# Access Compliance Report

## Public Rights-of-Way

### (Curb Ramps)

Intersection ID: N/A	Main Street: EASTWAY_DR	Cross Street: N/A	Location: NE
ADA ID: 464A74250207	Ramp Type: PerpDiag	Initial Pass/Fail: Fail	Overall Compliance: No
Codes/Mitigation Info/Possible Solution		Field Measurements/Component Compliance

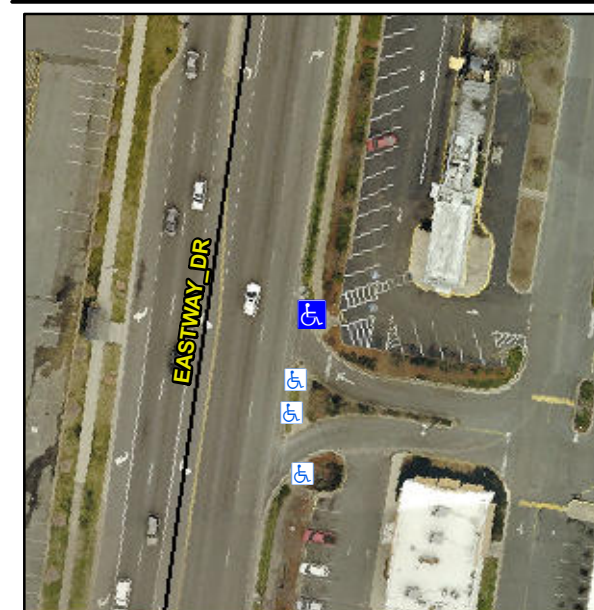
**Not Found, R304.5.1**

Compliance	Description	Data	Compliance	Description	Data
N/A	Ramp Length (in)	63.0	Yes	Ramp Slope (%)	5.3
No	Ramp Width (in)	37.0	Yes	Ramp XSlope (%)	2.0
N/A	Flare Type LT	N/A	N/A	Flare Type RT	N/A
N/A	Flare Slope LT (%)	N/A	N/A	Flare Slope RT (%)	N/A
N/A	Flare Traversable LT?	N/A	N/A	Flare Traversable RT?	N/A
N/A	Landing Length (in)	N/A	N/A	DWS Provided?	N/A
N/A	Landing Width (in)	N/A	N/A	DWS Contrast?	N/A
N/A	Landing Slope (%)	N/A	N/A	DWS Length (in)	N/A
N/A	Landing X Slope (%)	N/A	N/A	DWS Full Width?	N/A
N/A	Landing Curb? (Y/N)	N/A	N/A	DWS Offset (in)	N/A
N/A	Shared Landing?	N/A			
N/A	Gutter Ponding?	N/A	N/A	Gutter Slope (%)	N/A
N/A	Gutter Lip Ht (in)	N/A	N/A	Gutter X Slope (%)	N/A
N/A	Painted X Walk1?	No	N/A	Painted X Walk2?	No
	X Walk 1 Direction	To W		X Walk 2 Direction	To S
N/A	X Walk 1 Width (in)	N/A	N/A	X Walk 2 Width (in)	N/A
	X Walk 1 Slope (%)	2.8		X Walk 2 Slope (%)	0.4
	X Walk 1 X Slope (%)	2.5		X Walk 2 X Slope (%)	3.7

**Remove & Replace Curb Ramp With Two New Directional Ramps or Equivalent.**
